CHANGE ORDER

No. 1 (Balancing)

Project Primrose Lift Station and Force Main Upgrades

OWNER's Contract No. S091101

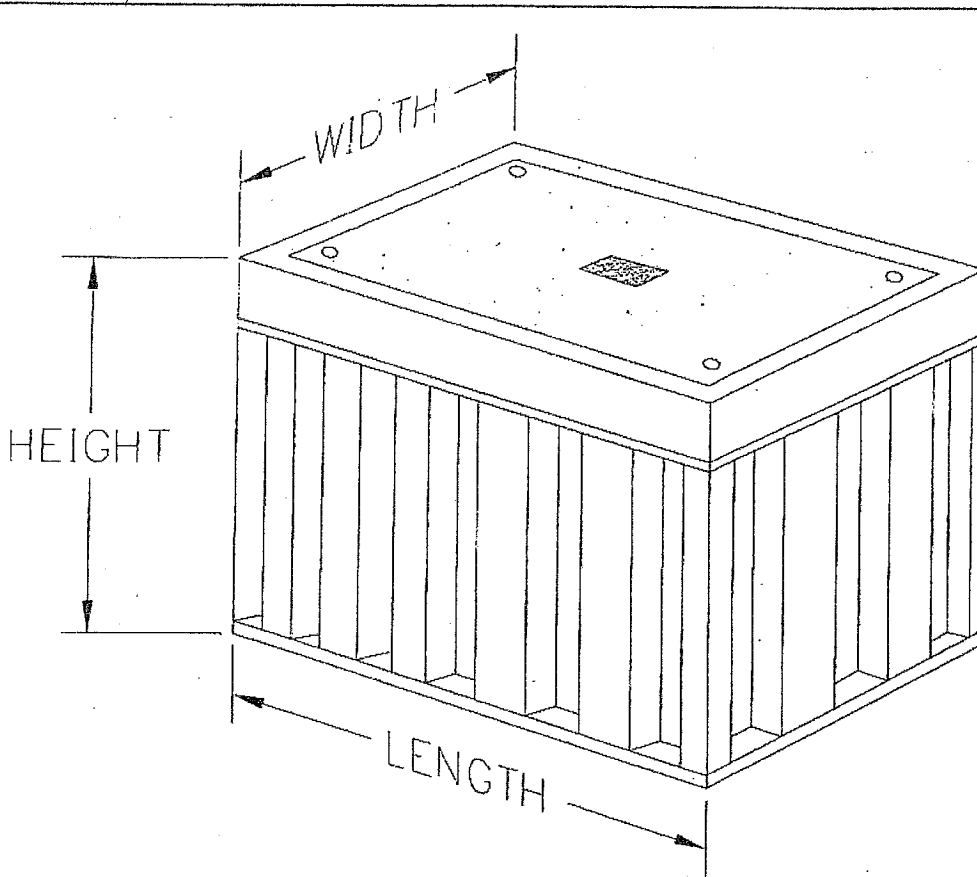
From: Thomas Behan [<mailto:thomasb@bldllc.net>]
Sent: Thursday, December 03, 2015 2:08 PM
To: AUCOIN, CHAD J
Subject: Primrose Pull Box

Chad,

See attached drawings. Please see on page 2 the size of the pull box. Is this the correct size of the pull box?

That is the correct size pull box. The standard continuous conduit that Entergy installs is SDR 13.5 HDPE.
